AGENDA SECTION: PUBLIC HEARINGS	ORIGINATING DEPT: PLANNING	ITEM NO. E-1
ITEM DESCRIPTION: Amendment to General Development Plan #190 by Bigelow Enterprises known as Harvestview. Land uses proposed include single family attached dwellings and a mixed commercial/residential district on approximately 17.09 acres of land. The Plan identifies both public and private road, including connections to adjacent properties. The property is located along the north side of 55 th Street NW and along the west side of 50 th Avenue NW.		PREPARED BY: Brent Svenby, Planner
<p>March 31, 2003</p> <p><u>City Planning and Zoning Commission Recommendation:</u></p> <p>On March 12, 2003 the City Planning and Zoning Commission reviewed an amendment to the Harvestview General Development Plan. The Commission also reviewed amendments to Special District language.</p> <p>The Commission reviewed this proposal according to the criteria listed in Paragraph 61.215 of the Zoning Ordinance and Land Development Manual.</p> <p>Mr. Haeussinger moved to recommend approval of Amendment to General Development Plan #190 known as Harvestview with the staff-recommended findings and conditions. Ms. Petersson seconded the motion

HARVESTVIEW
GENERAL DEVELOPMENT PLAN

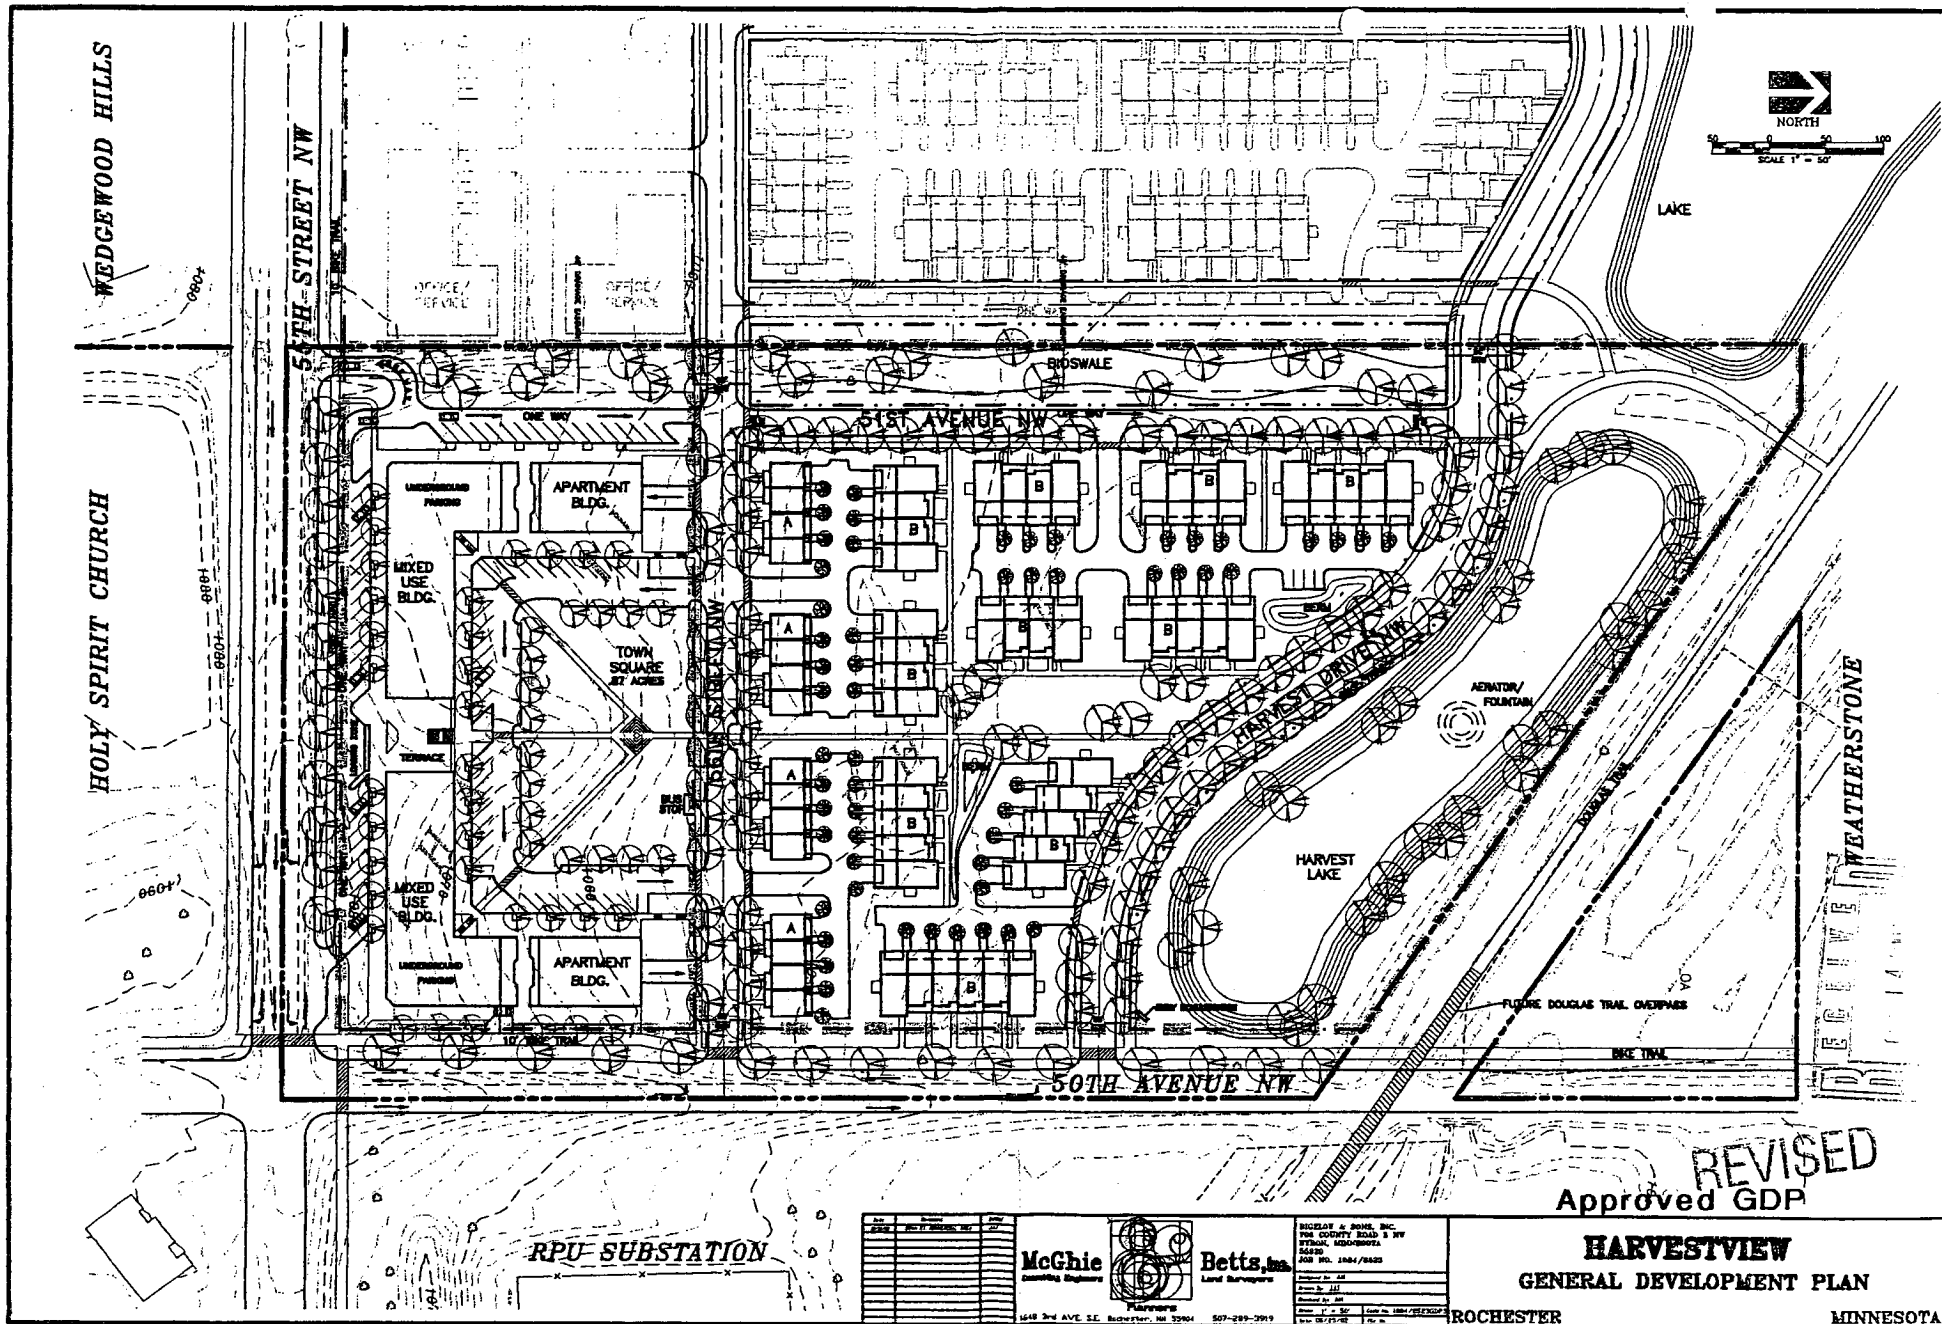
The major amendments to the GDP occur in the Town Center portion of the plan. The approved GDP has one-way parking and traffic around the town square as well as a one-way loop of parking under the buildings. The proposed amendment has two-way traffic around the town square with the drive aisle actually going into the underground parking. The amendment also proposes a parking area on the west side of the property south of 56th Street NW which in the approved GDP is shown as a drainage easement. With the proposed amendment the drainage would need to be confined to pipes under the parking area. The other proposed amendment is the condo building on the east side of the site. Parking access to this building would be from the parking area to the west of the building but traffic exiting the building would exit onto 56th Street NW.

HARVESTVIEW
AMENDED GENERAL DEVELOPMENT PLAN
ROCHESTER MINNESOTA

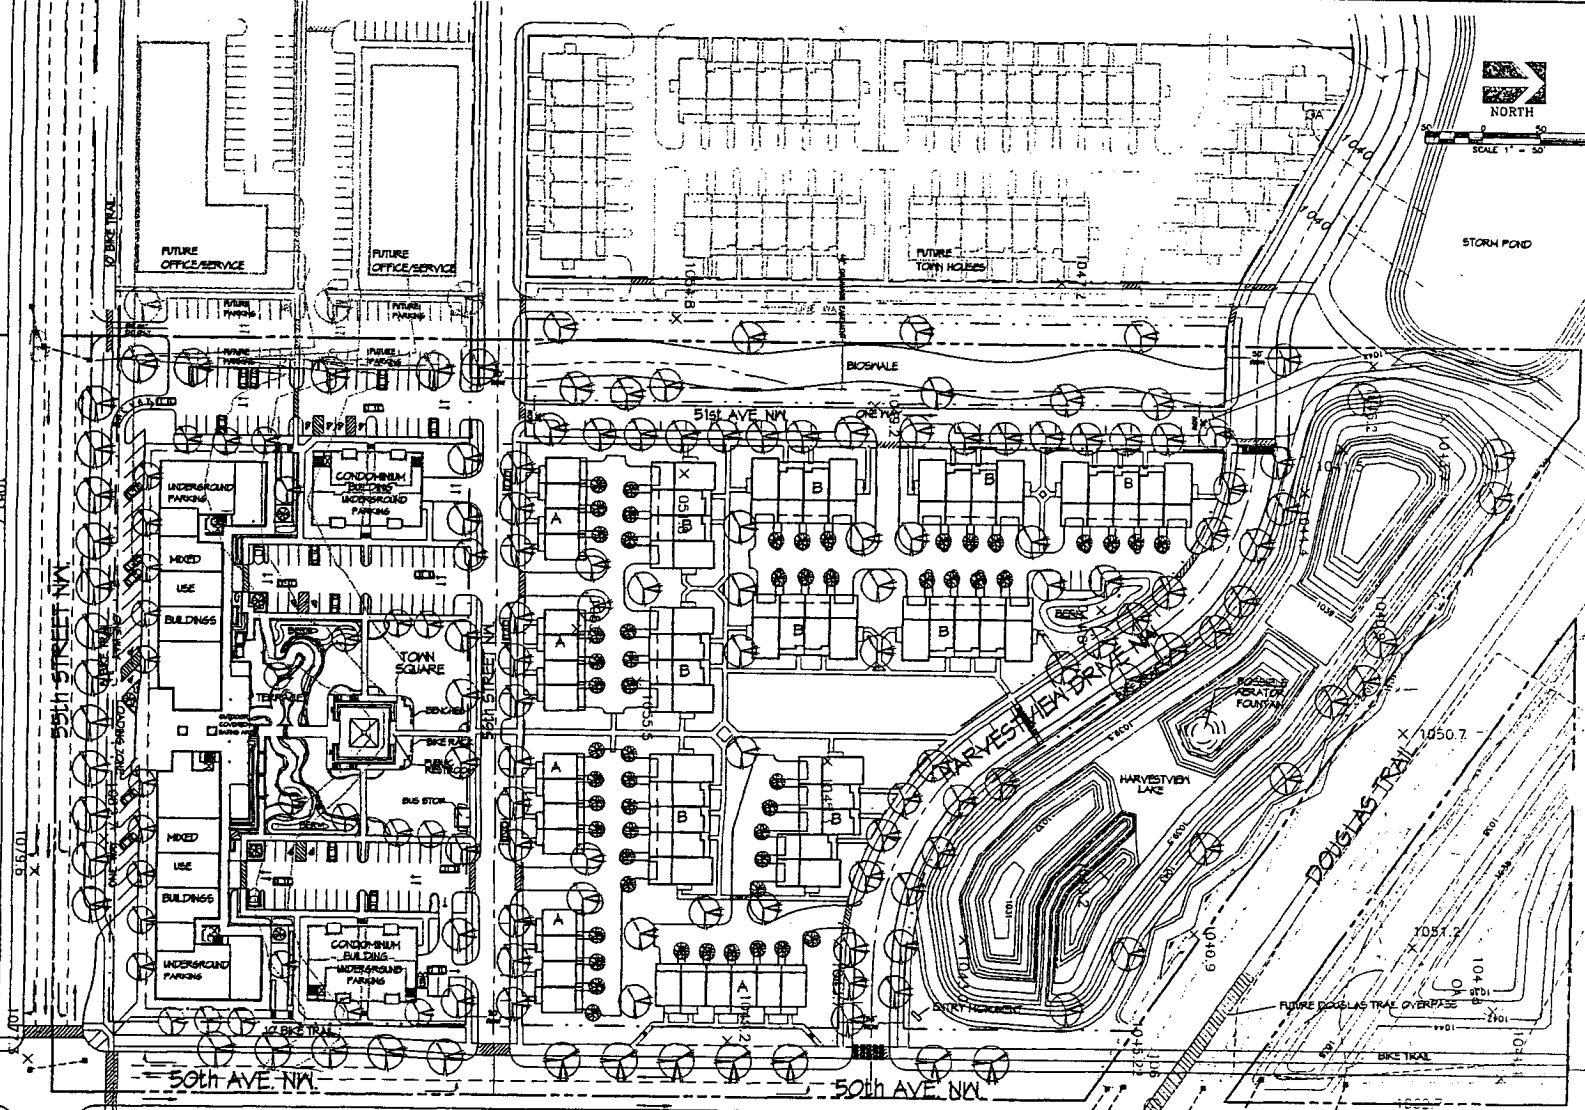
Overall the proposed amendment to the GDP shows less landscaping (street trees) than what is shown on the approved plan.

1. The use of the roadway name **HARVEST** as stated in the Amended General Development Plan and the Preliminary Plat cannot be used, as it would cause duplication of roadway name.

1. With the elimination of the previously planned looped roadway and the water system around the town square two dead end roadways and water main stubs are created. This will affect both water quality and reliability for the entire area south of 56th St NW. Careful consideration must be made in the placement of the service connections to the four large buildings to avoid potential problems.

- 1. The applicant shall amend the existing Development Agreement with the City of Rochester to address the change in purposed use from single-family low density residential to a mixed use of commercial, multi-family residential and low density residential.***

- 2. Prior to or concurrent with final platting, ownership and maintenance of the area shown as the "town square" shall be address.***
- 3. When the property is platted controlled access will be required along the entire frontage of 55th St NW, and 50th Ave NW, with the exception of any approved street accesses, and/or private drive accesses approved through the GDP process.***

- 4. Pedestrian facilities will be required along both sides of all new public roads within this property, as well as, a bituminous path along the entire frontage of 55th St NW, and the easterly frontage of 50th Ave NW. The Owner's obligations regarding the required pedestrian paths are addressed in the existing Development Agreement.***
